**Product Change Notice**

Type of Notification: Changing Chassis

PLA300F-□

**Fig. 2.1 Drawing Comparison between Existing and Changed**

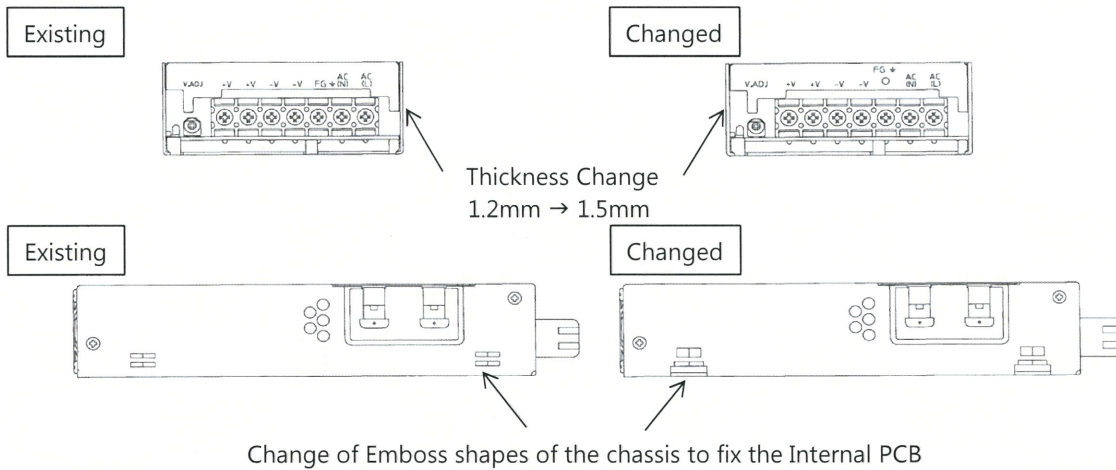
The metal cases (Cover and Chassis) of PLA300F will change as shown in Table 2.1 in order to improve procurement availability. These changes do not impact the electronic, the mechanical specification and the safety standard compliance.

#	Components	Description	Notes
1	Upper metal case (Cover)	A place of the FG punch mark moves to the upper area.	
		The screw hole is added beneath the FG punch mark.	
2	Lower metal case (Chassis)	The thickness changes from 1.2mm to 1.5mm.	
		Emboss shapes of the chassis to fix the internal PCB change.
